**ADDENDUM #3**

To: All Bidders  
Project Name: Renovations to:  
GVSD District Administration Office  
100 Lindenwood Drive, Malvern, PA 19355  
Prepared for: Great Valley School District  
301 Lindenwood Drive  
Malvern, PA 19355  
Date: January 13, 2023

Notice to all Contractors bidding the Renovations to the GVSD District Administration Office. This Addendum is to amend or clarify the Contract documents as follows:

## 1 | TYP. FIXED PANEL PARTITION WALL SECTION

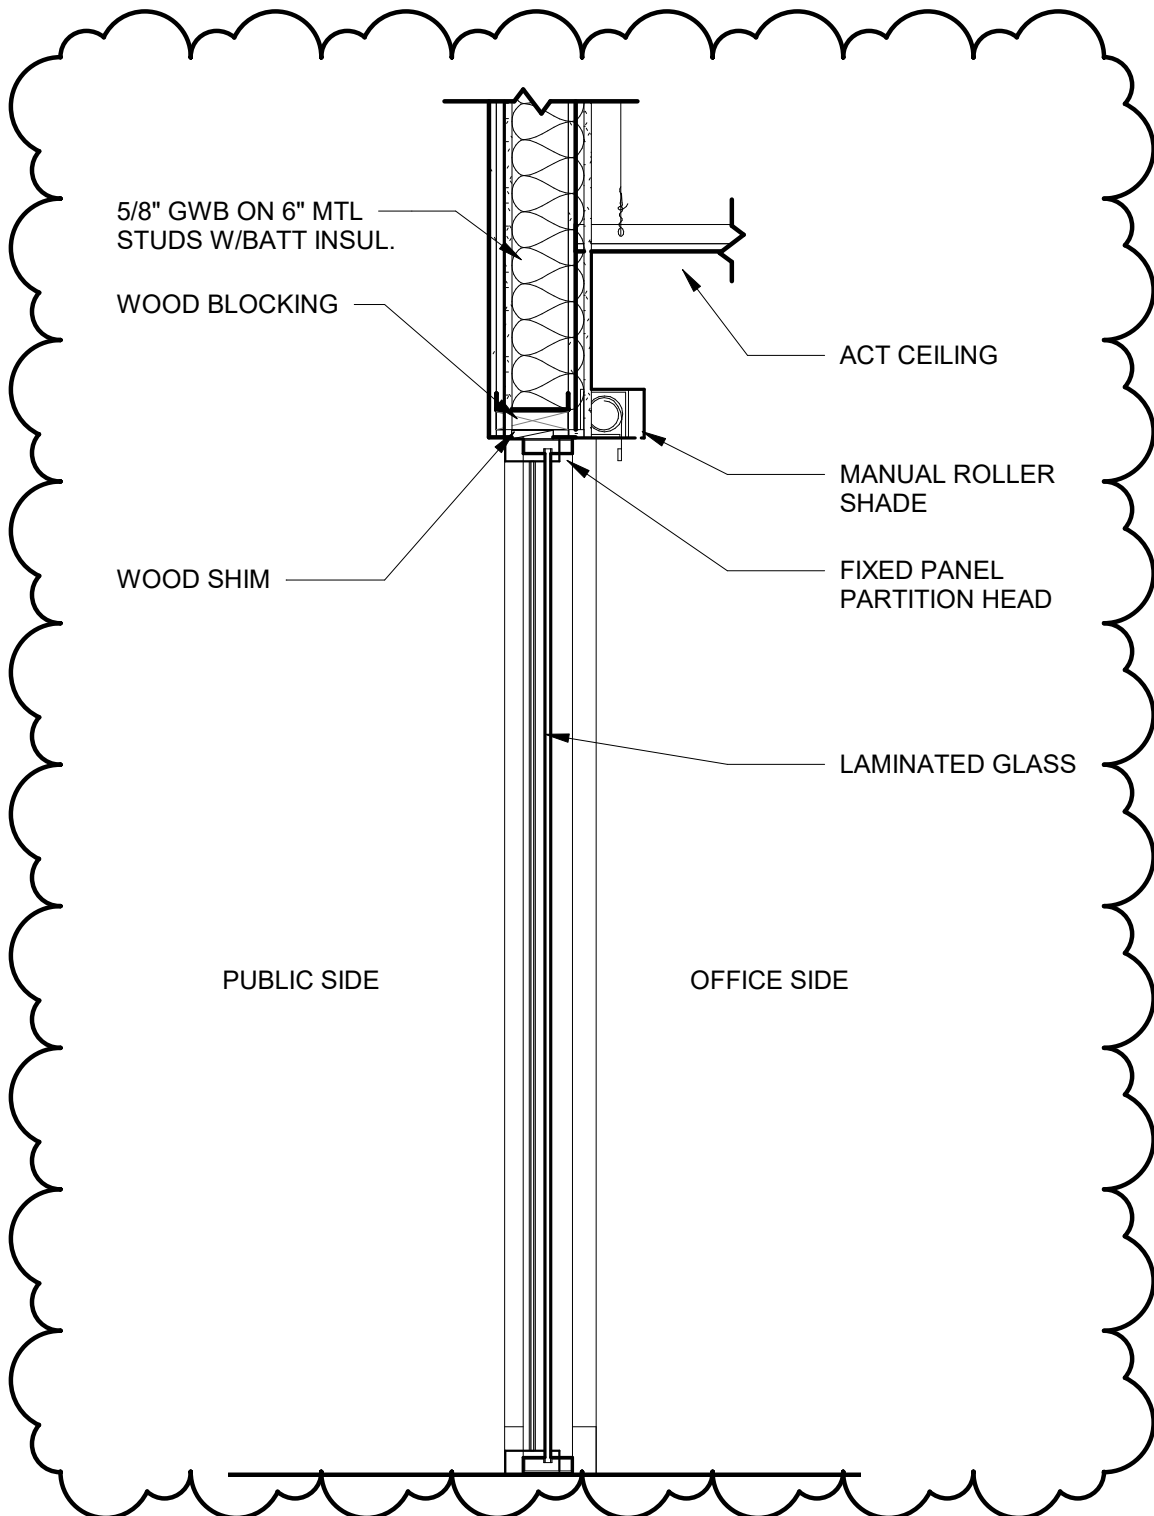
- 2.01 Drawing A110: **ADD** dimensions, wall type tags and wall detail tag as shown on attached drawing under this addendum.
- 2.02 Drawing A501: **ADD** details for Typical Jamb Profiles and Typical Fixed Panel Partition Wall Section as shown on sketch, AD3-A01.
- 2.03 Drawing A851: Detail 3, **MODIFY** note to read 12" CAST LETTER.
